BT54.15-D-2601-01A	Hydraulic pump relay equipment for sprintshift transmission modified		
--------------------	--	--	--

**MODELS**

**901.6, 902.6, 903.6, 904.6  
with TRANSMISSION 716.643  
with CODE (GD5) Automated  
manual transmission 716.643**

D26.19-1143-01

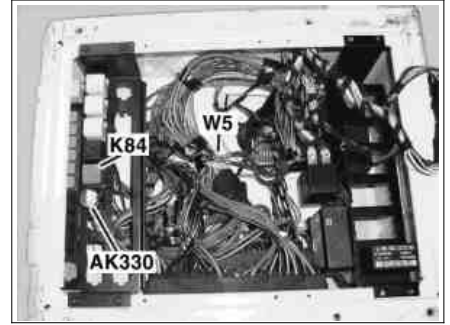
In vehicles as of VIN end no. R 238 045 to R 453 443, existing relay K84, manufactured by Tyco (part number 002 542 13 19) or manufactured by Hella (part number 002 542 23 19) must be changed to relay 002 542 59 19 to prevent damaging the sprintshift hydraulic pump.

On vehicles as of VIN end no. 238 045 with existing diode AK330, relay K84 (manufactured by Hella, part number 02 542 59 19) can be installed without modification.

**i** A rectifier diode is integrated in the relay 002 542 59 19.
